Subject: **Request for Modification of Section 404 General Permit No. 198200031 and Section 401 Water Quality Certification, and lifting of Notice of Violation Status** for the Interstate 85 (I-85) widening and interchange improvements from north of NC 73 to north of SR 1280, Cabarrus and Rowan Counties, Divisions 9 and 10. Federal Aid Project No. NHIMF-085-2(61)55, TIP I-3802A.

The North Carolina Department of Transportation (NCDOT) requests modification to the existing General Permit No. 198200031 and associated Water Quality Certification for widening and interchange improvements along I-85 in Cabarrus and Rowan Counties. This project is currently under construction.

Revisions have been made to seventeen impact sites and are discussed in detail below. Two new impact sites are also discussed below (Site 36 and the Troutman waste site).

**SITE #36**

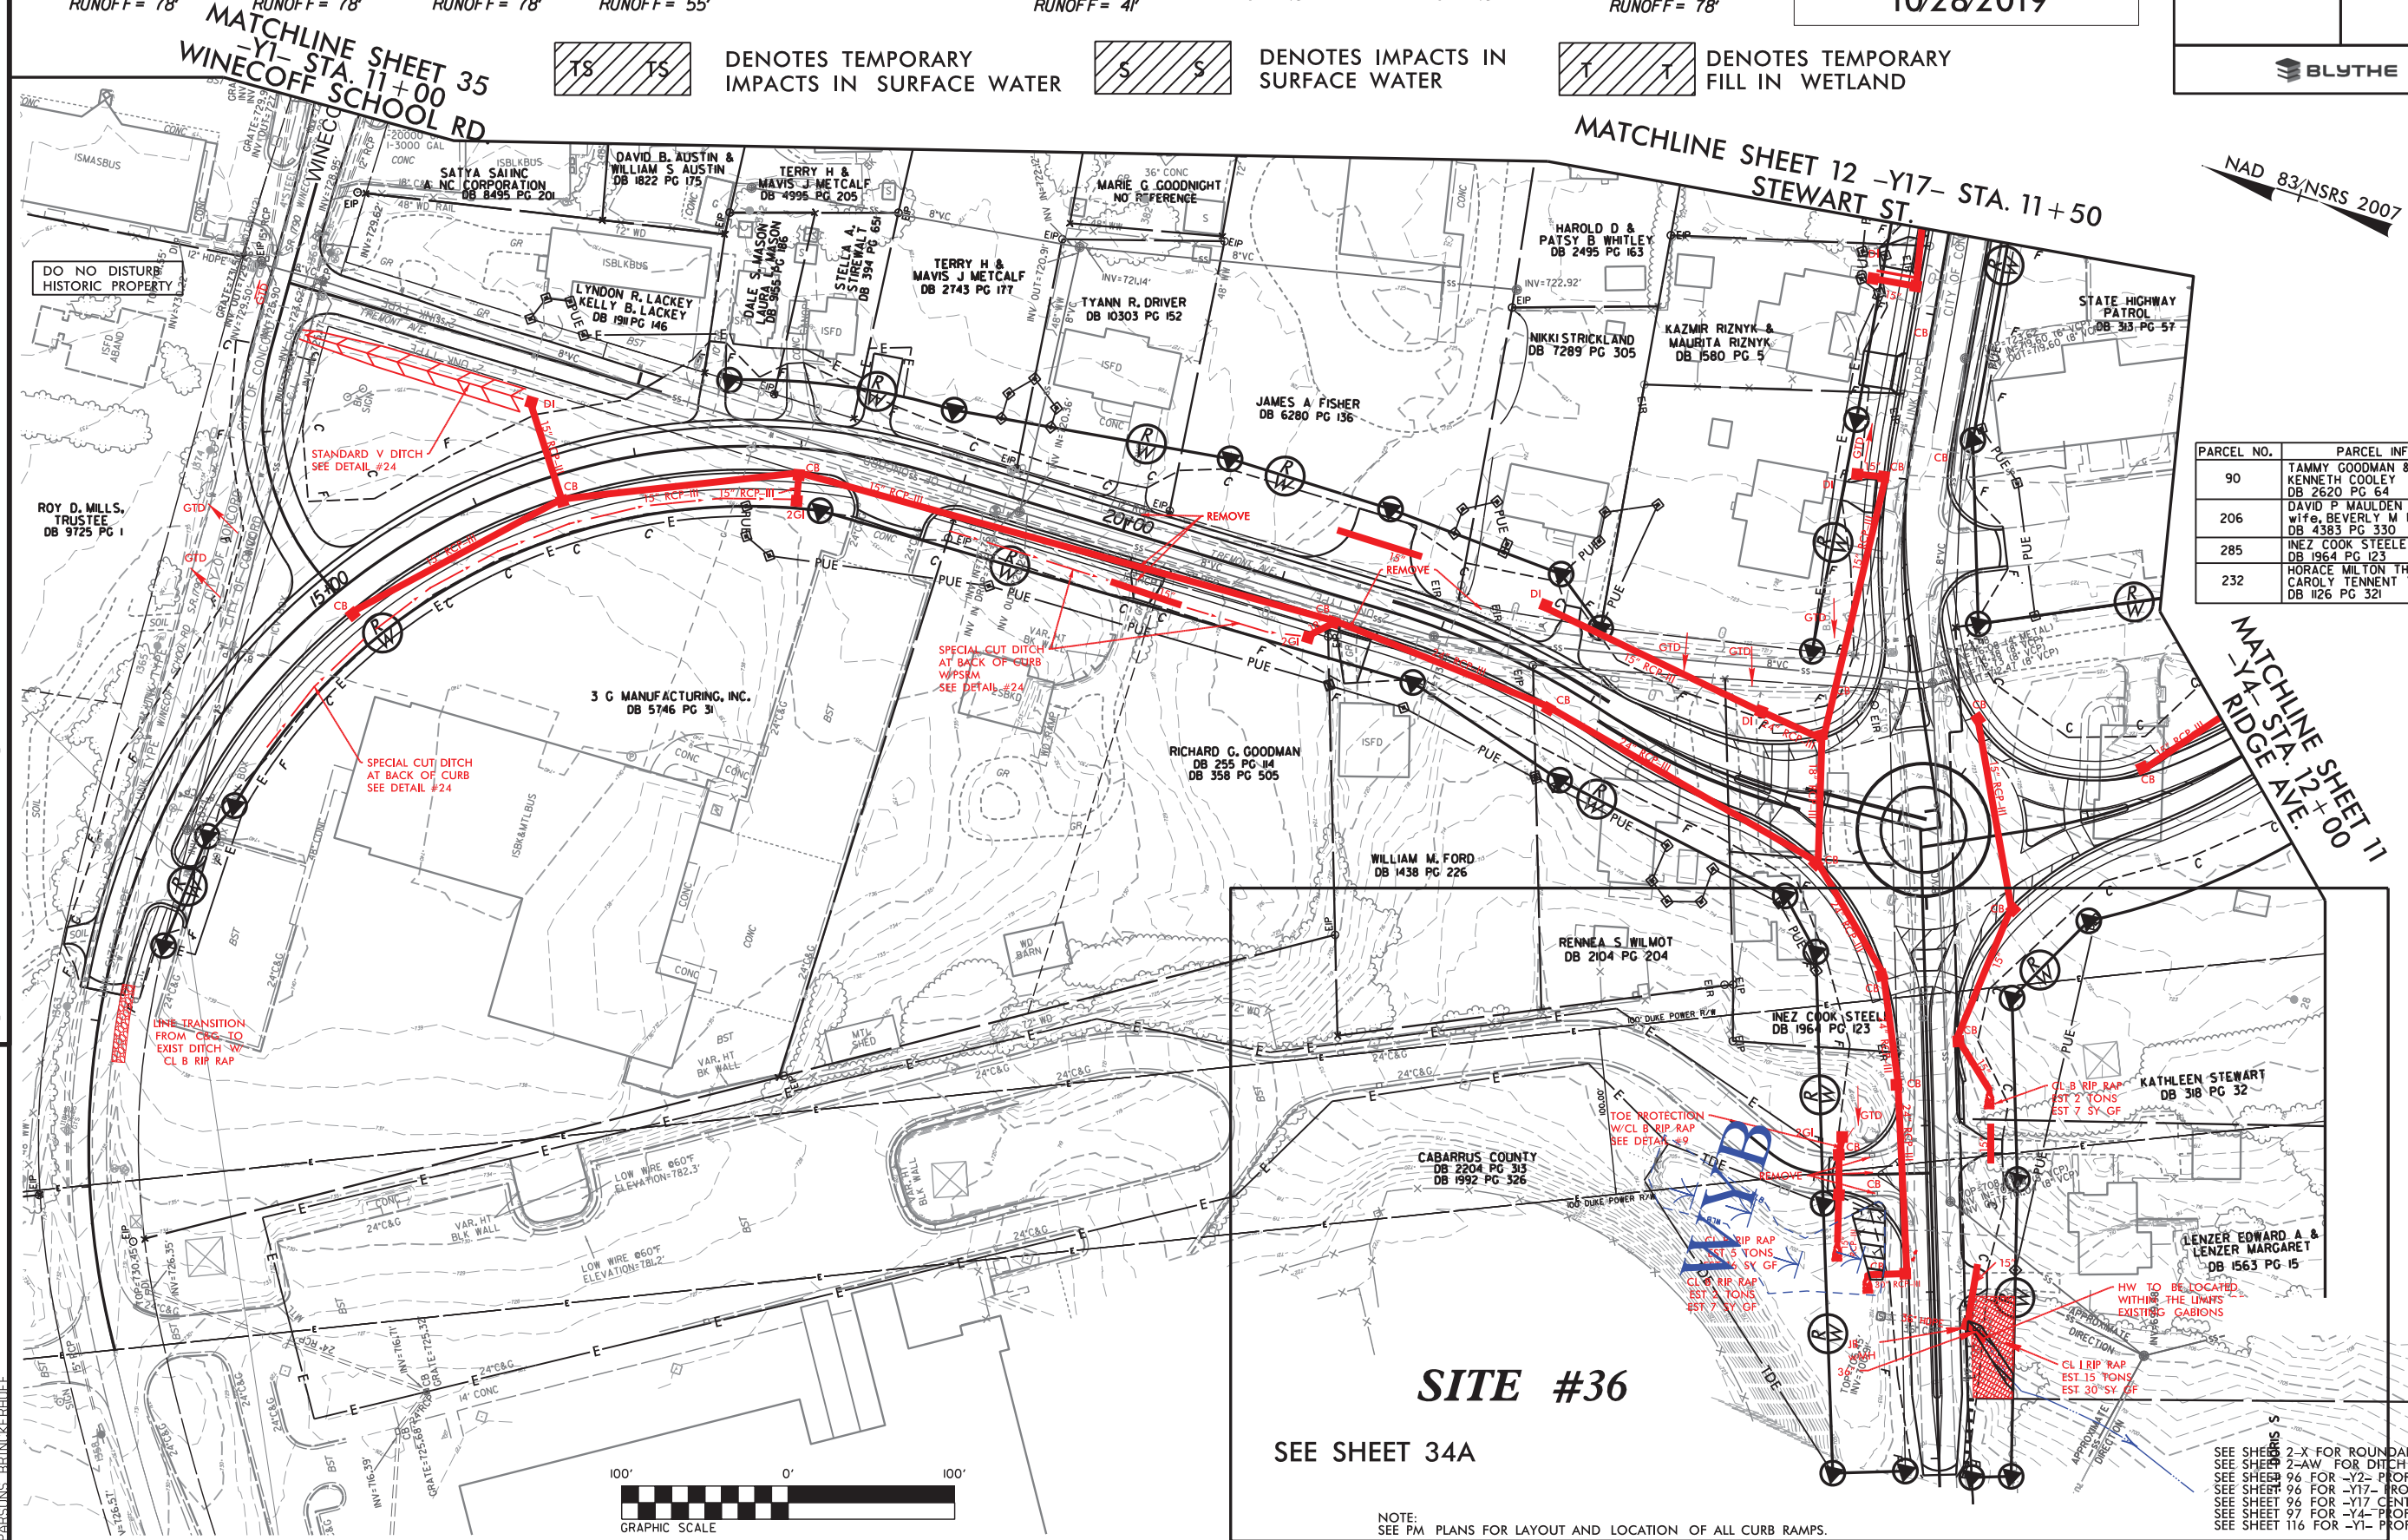
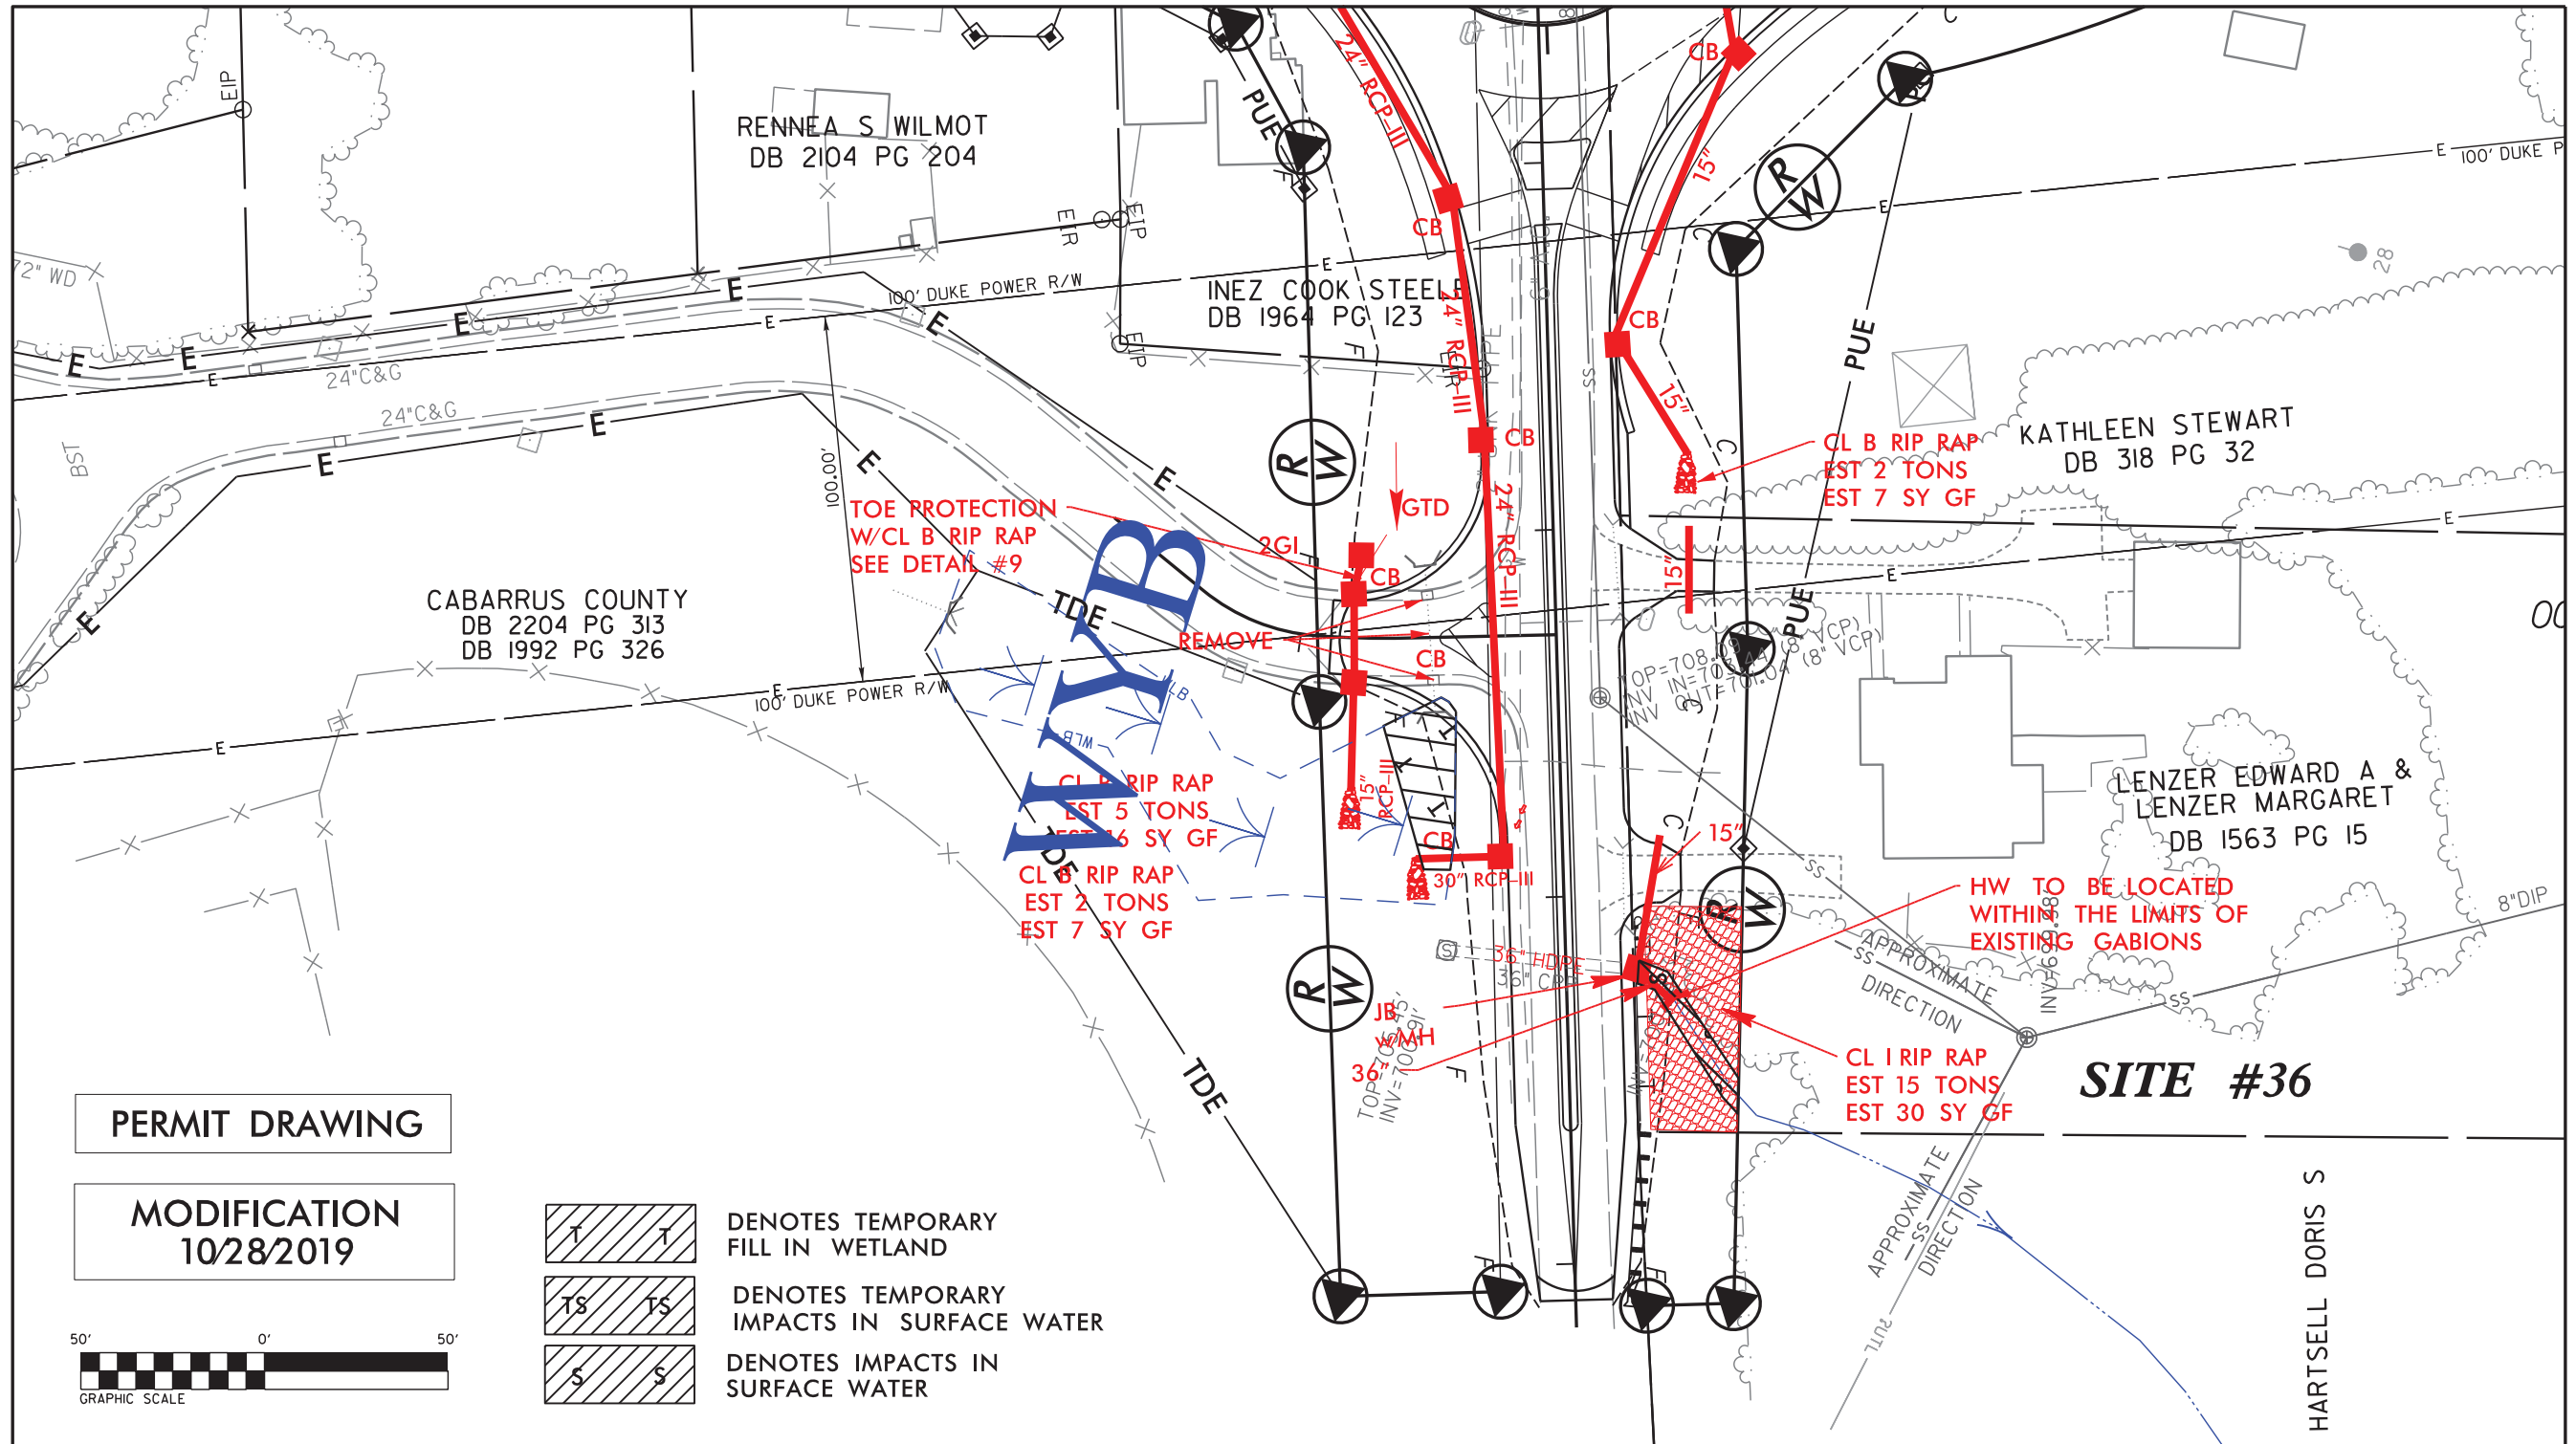
Site 36 (Sheet 34) –This site has been added to account for impacts resulting from the extension of an existing 36” pipe and installation of Class I rip rap in the stream bed at the pipe outlet. The pipe is located at the edge of the study limits and the stream was not identified in the original Jurisdictional Determination (JD). Permanent stream impacts increased from 0 linear feet to 61 linear feet. Also, a temporary sediment basin was added inadvertently in wetland WYB at the upstream end of the existing pipe crossing, resulting in 0.01 acre of temporary fill wetland impacts.
